Re: Environmental Noise Study – Addendum #1 (revised and redlined)
655 Hurontario Street
Collingwood, Ontario
VCL File: 116-0451.100

Valcoustics Canada Ltd. (VCL) previously prepared an Environmental Noise Study, dated May 1, 2017, for the proposed residential development at 655 Hurontario Street in the Town of Collingwood. This addendum addresses changes to the mechanical design for the proposed development.

Title	Date	Figure 1
	Project Name	Project No.	
	Predicted Sound Levels due to HVAC Units	May 6, 2022	
	655 Hurontario Street (formerly 1 Lockhart Road)	116-0451-100

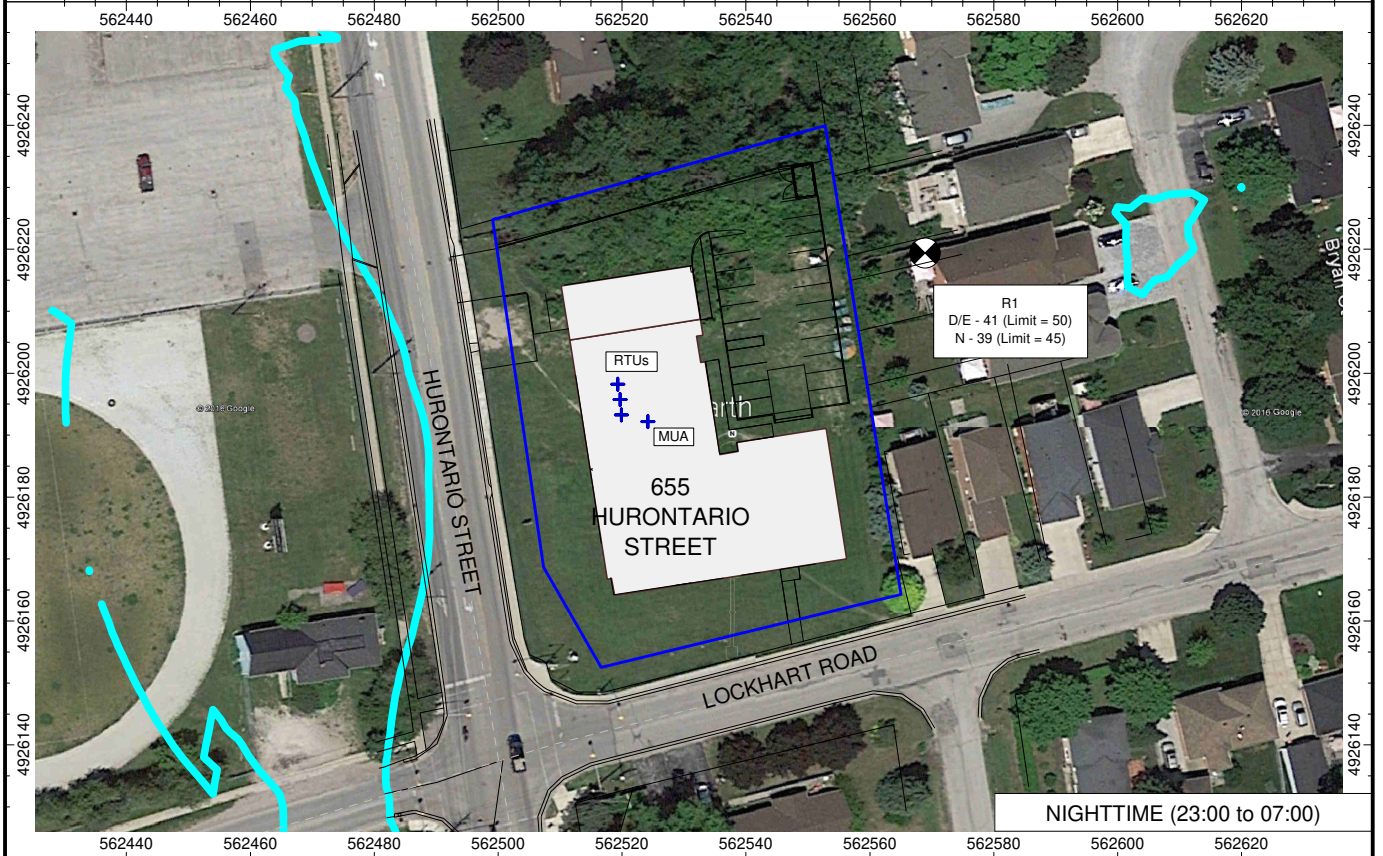
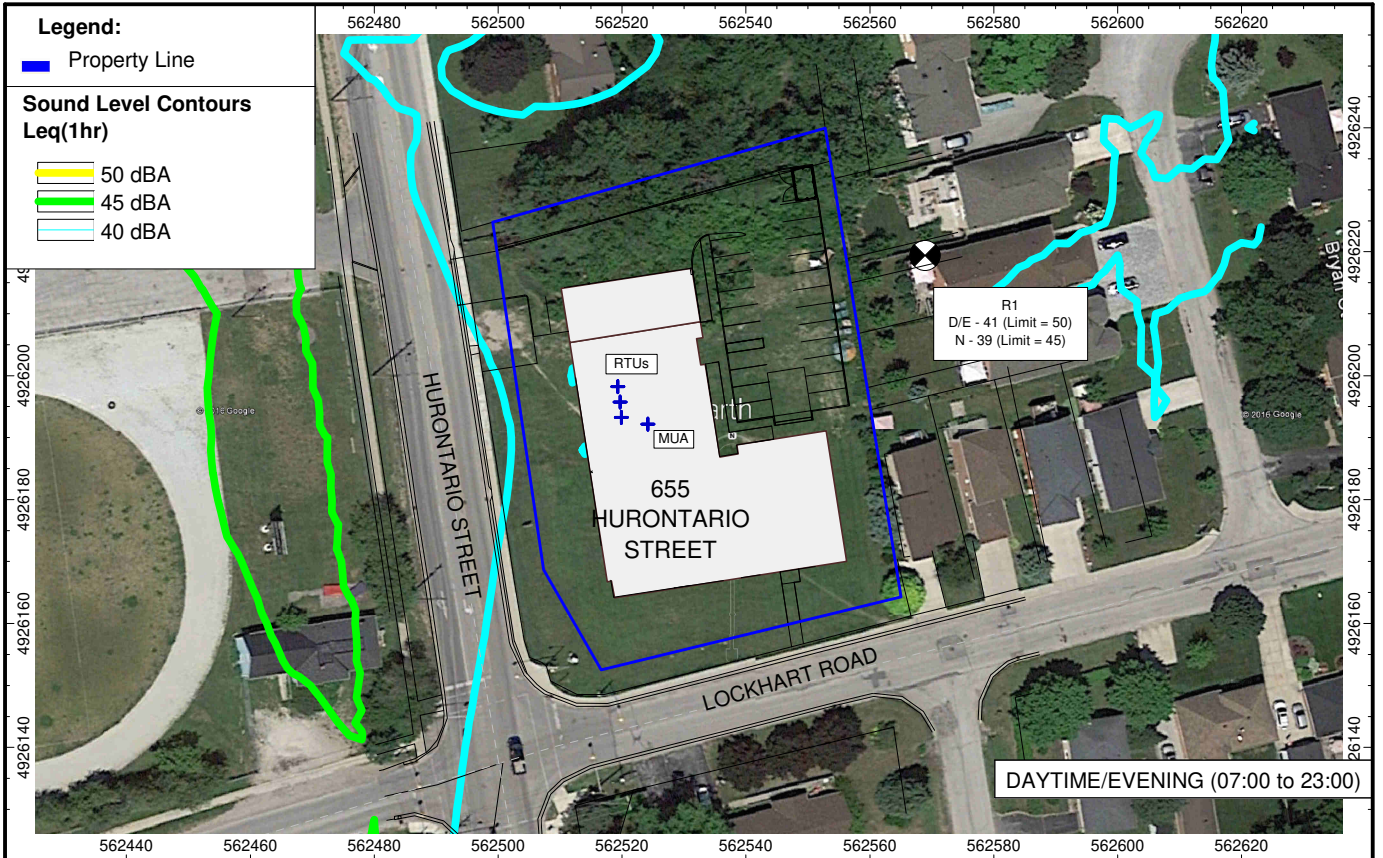
Figure 1 shows the predicted unmitigated sound level contours (50dBA yellow line, 45 dBA green line, and 40 dBA cyan line). For the daytime/evening scenario, the 50 dBA contour does not extend beyond the property line in any direction. For the nighttime scenario, the 45 dBA contour does not extend beyond the property line in any direction. The sound level limits are also met at the 2nd floor point receptor. [Additional data for the acoustical model is also appended to this letter \(showing sound power data for all sources and duty cycle data\).](#)

Based on the above, mitigation is not recommended for the updated mechanical design. Note that if the equipment selection or design changes, the analysis should be updated. Also, the analysis should be confirmed once sound data is available for the make-up-air (MUA) unit.
